AXOD/AXODE (AX4S) UPDATE HANDBOOK

INTRODUCTION

*Updated
October, 2002*

Figure 18

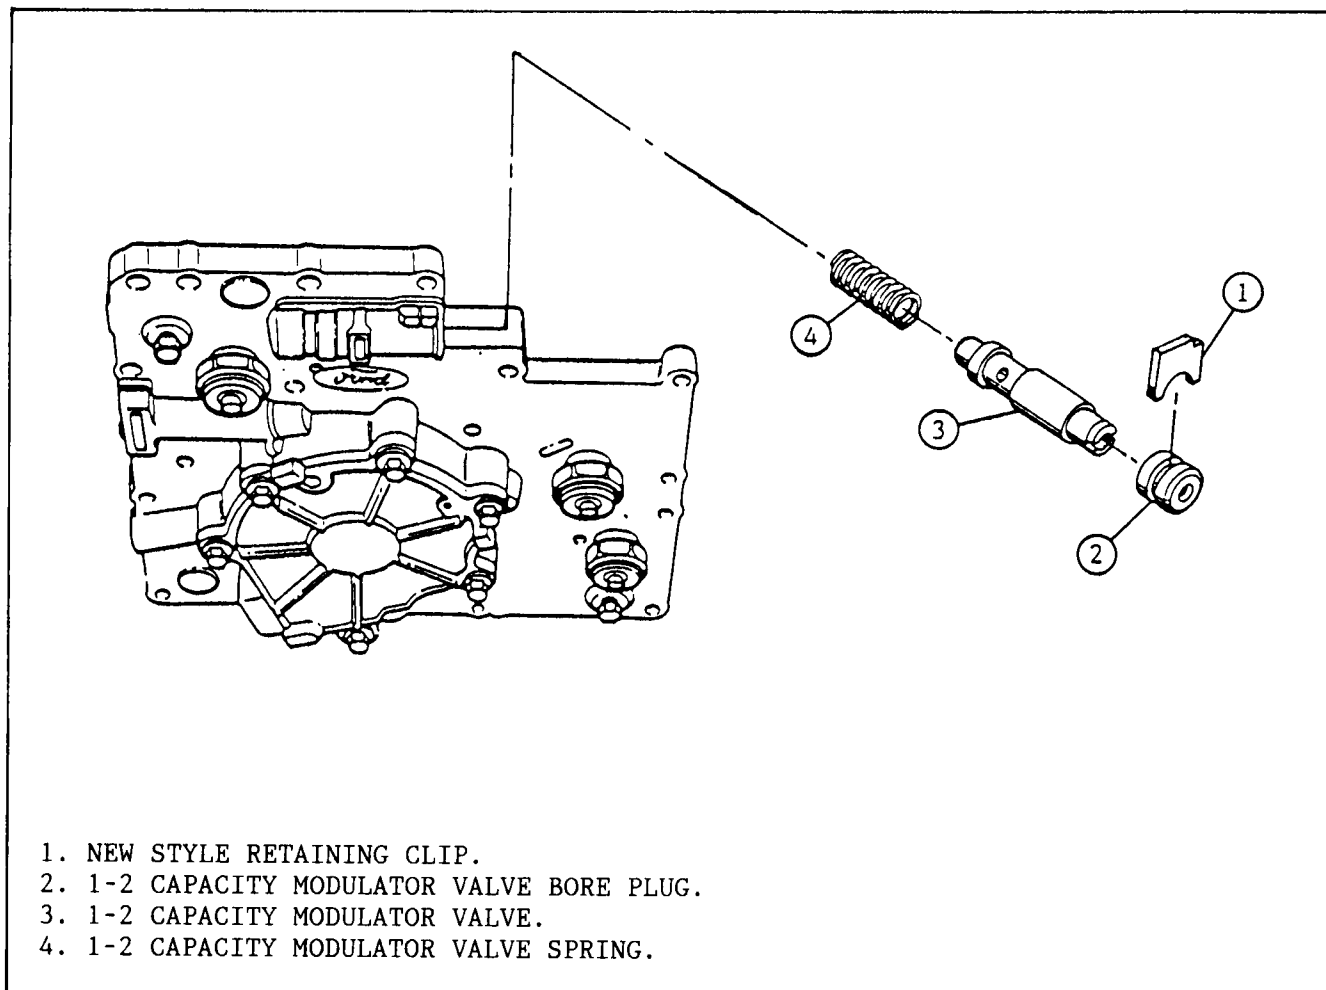
CORRECTION: FOR SOFT 1-2 SHIFT:
Replace the 1-2 capacity modulator valve spring with the Red spring manufactured by Shift Technology Products (Part #K006). The kit also comes with a new style bore plug retaining clip. Assemble into the oil pump as shown in Figure 18. This modification should be made on all AXOD'S during rebuild.

NOTE: Do not install the valve backwards, as the result will be a one-neutral shift.

Figure 19

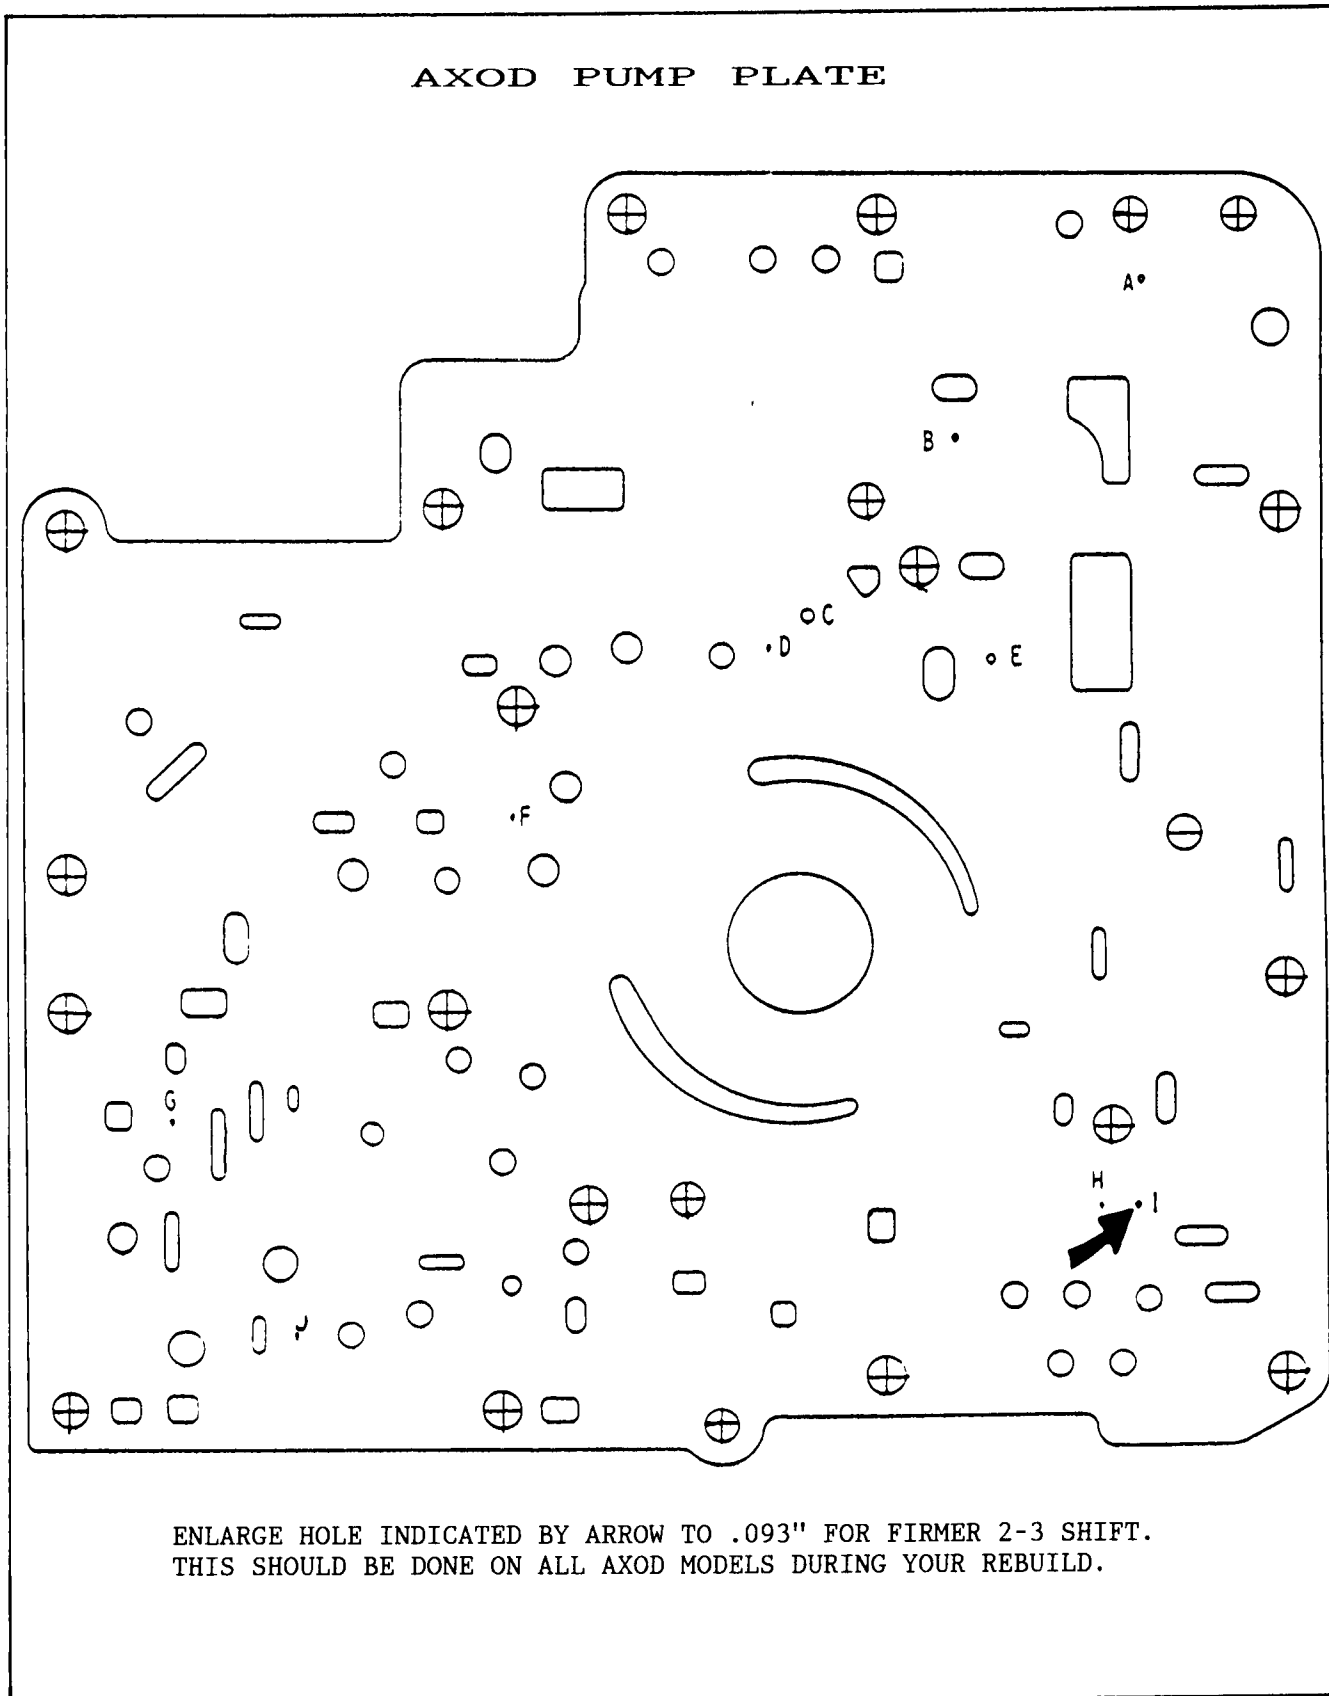
FOR SOFT 2-3 SHIFT:
Drill the direct clutch feed passage in the oil pump spacer plate, hole marked "I", out to .093" as shown in Figure 19.

Figure 37

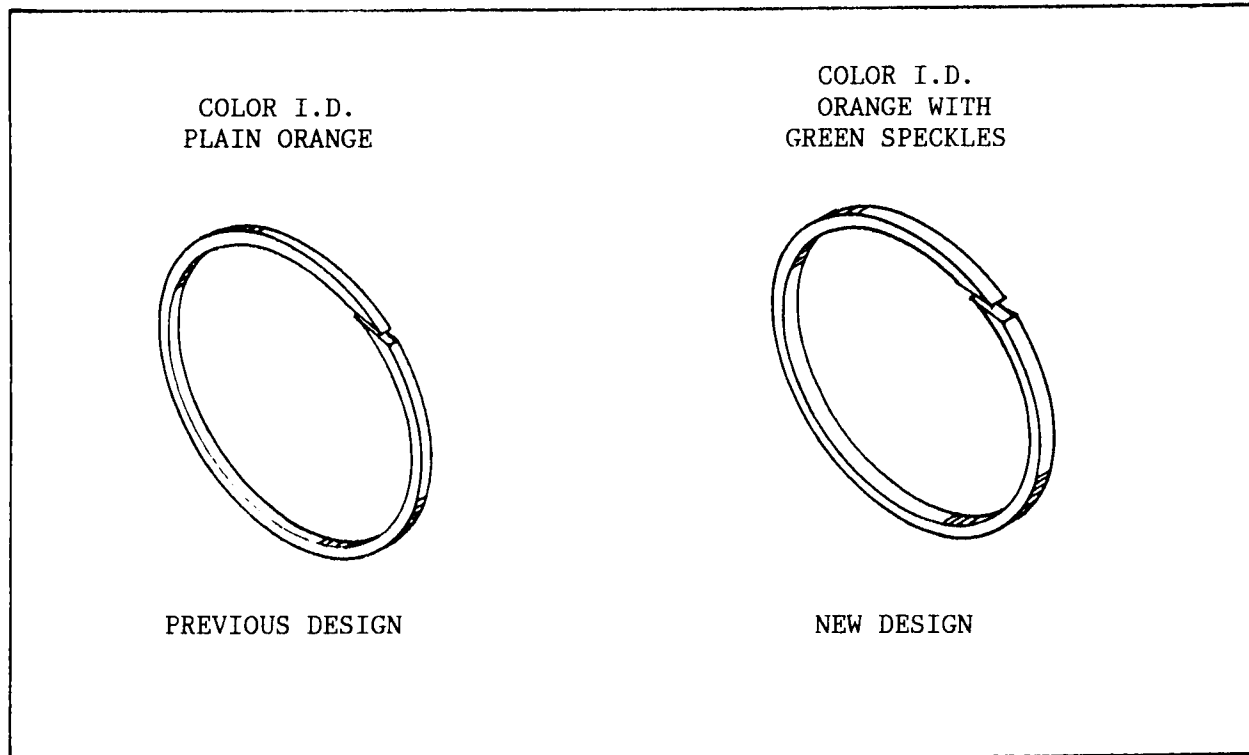
The five sealing rings on the driven sprocket support have been re-designed to help eliminate leakage in this area. The width of the sealing rings has been increased by approximately .015", and the new color identification is orange with green speckles (See Figure 37). The previous design sealing rings were plain orange in color.

The new design sealing rings are available under OEM number E6DZ-7D019-A, and should be used on ALL previous model AXOD transaxles.

DO NOT USE PREVIOUS DESIGN SEALING RINGS.

Figure 38

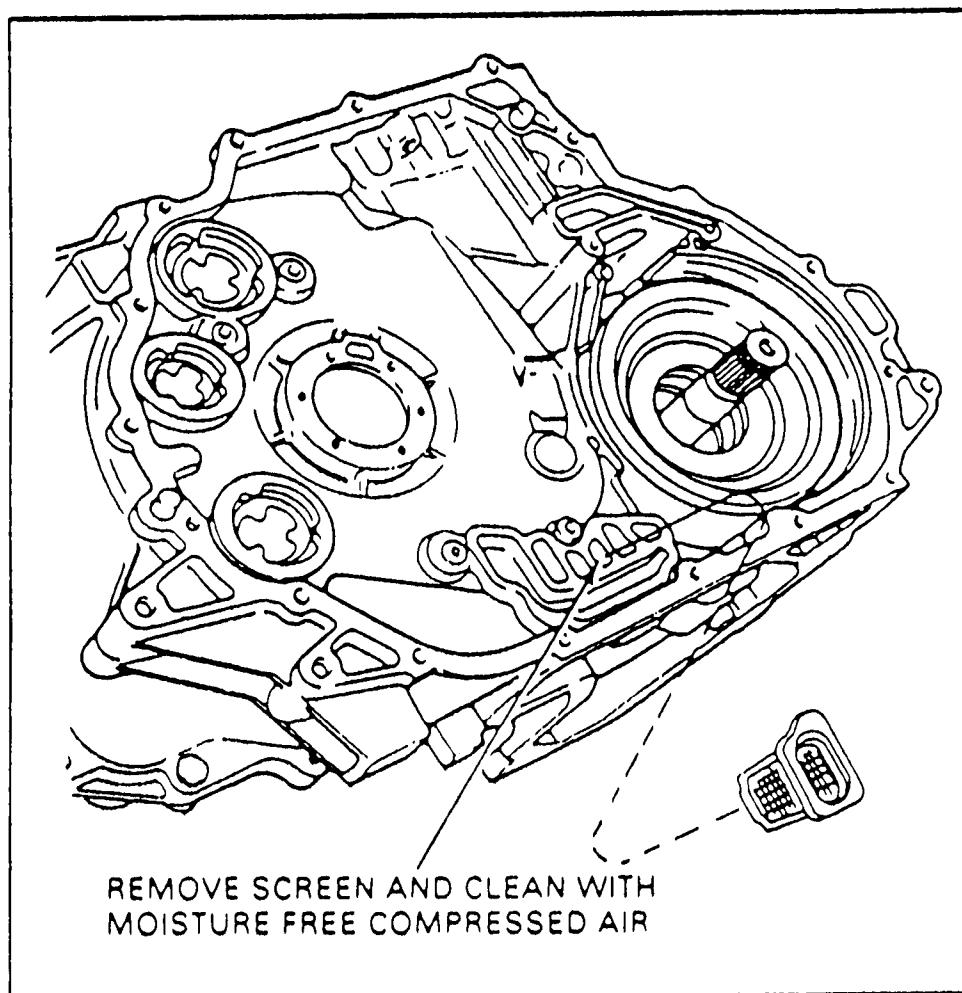
CHANGE: A new filter has been added to the 1989 AXOD 1-2 servo apply circuit as shown in Figure 38.

Figure 40

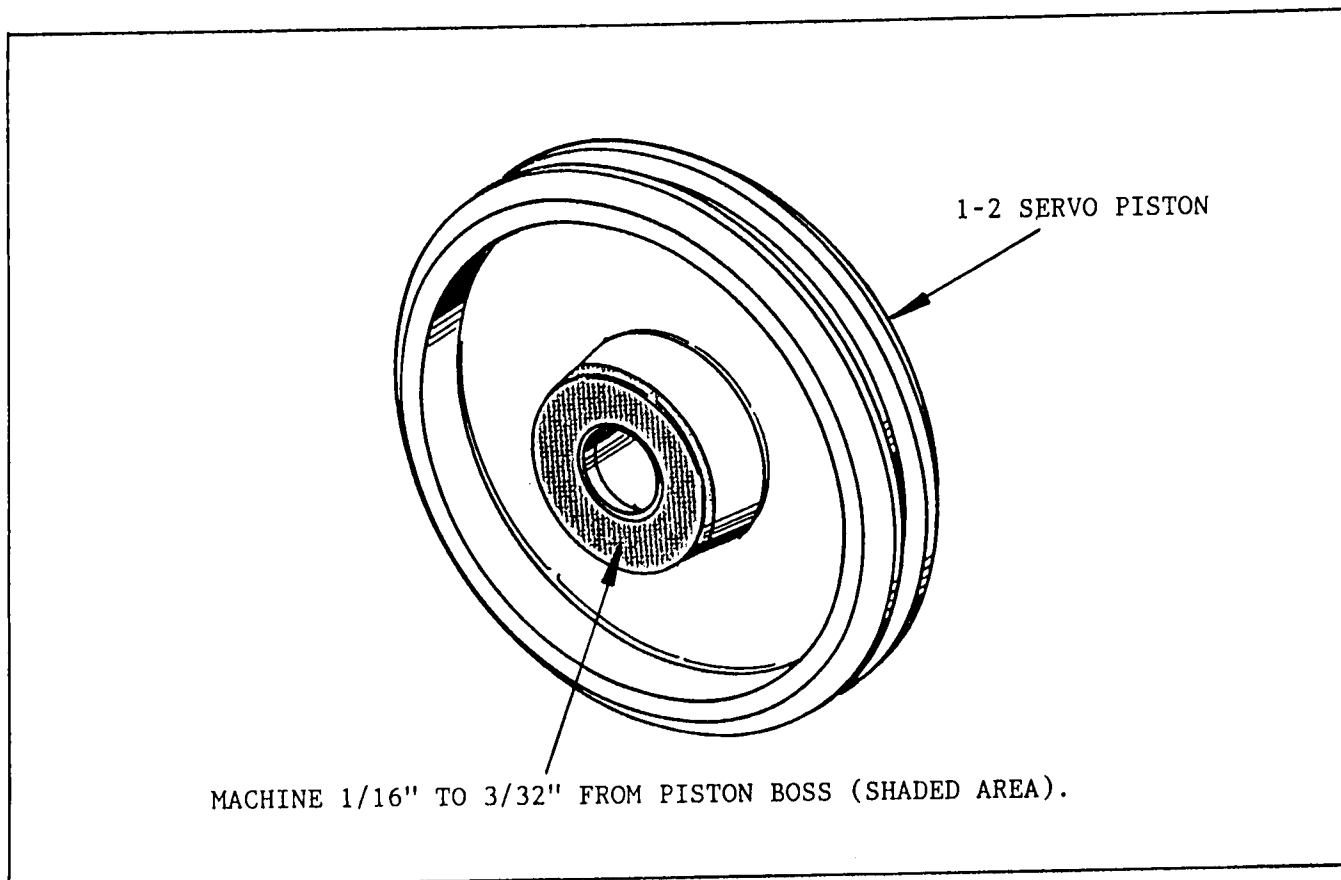
CAUSE: Insufficient travel of the 1-2 piston against the cushion spring.

CORRECTION: Remove 1/16" to 3/32" from the boss on the inside of the 1-2 servo piston as shown in Figure 40. We have shaded the area to be machined (See Figure 40).

Figure 41

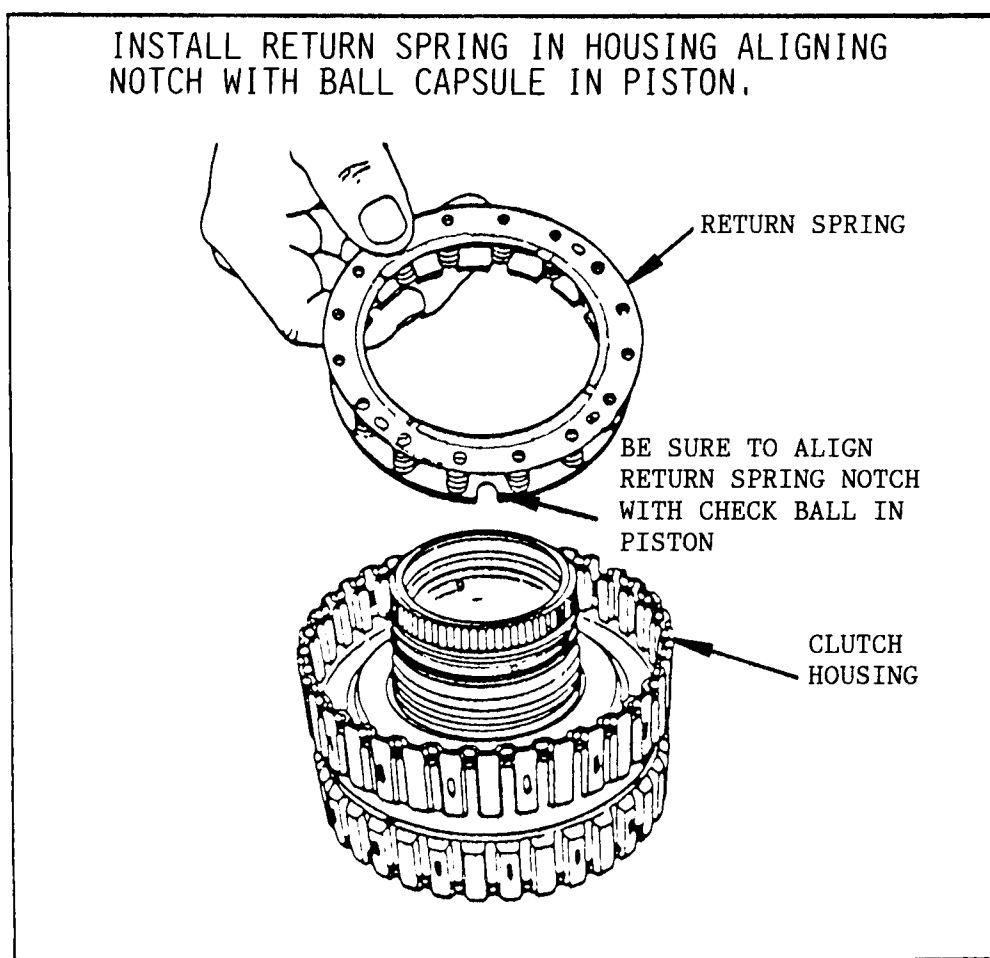
- COMPLAINT:** An extended 3-4 shift with possible direct clutch failure or a NO 3-4 shift condition.
- CAUSE:** This condition may be caused by a partially or fully blocked oil flow of the direct clutch piston check ball assembly.
- CORRECTION:** Special care must be taken during the overhaul operation when re-assembling the direct clutch return spring over the direct clutch piston. Make sure that the notch in the spring bottom retainer (See Figure 41) is positioned properly over the check ball capsule so as not to block or restrict oil flow of the check ball assembly. Refer to Figure 41.

Figure 43

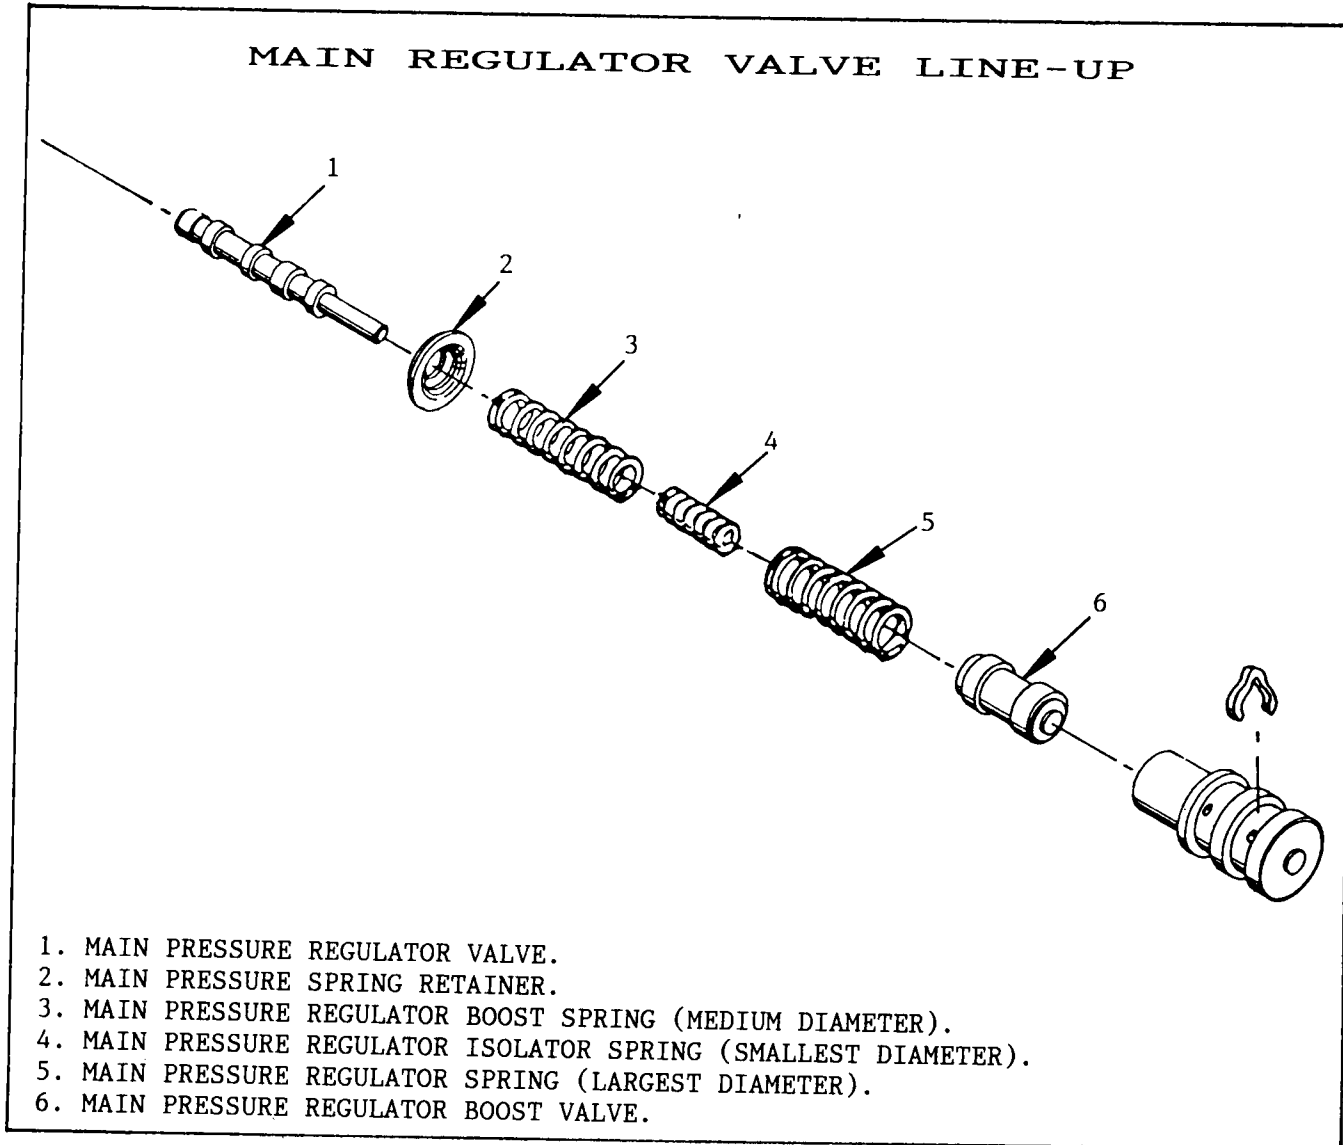
CAUSE: NO. 1. A "Shudder" during a 1-2 upshift will occur if the main pressure regulator "Isolator" spring is not installed after cleaning the valve body (See Figure 43). This is caused by fluctuations in main line pressure at the time of the 1-2 shift.

NO. 2. Delayed upshifts can be caused by the pressure regulator spring retainer being installed backwards (See Figure 43). This will create low main line pressure.

CORRECTION: NO. 1. Insure that all three (3) pressure regulator springs are re-installed in the valve body regulator bore (See Figure 43).

NO. 2. Insure that the main regulator spring retainer is installed in the proper direction (See Figure 43). The retainer is very similar to the one used in the AOD valve body, but is installed in the opposite direction of the AOD (See Figure 43).
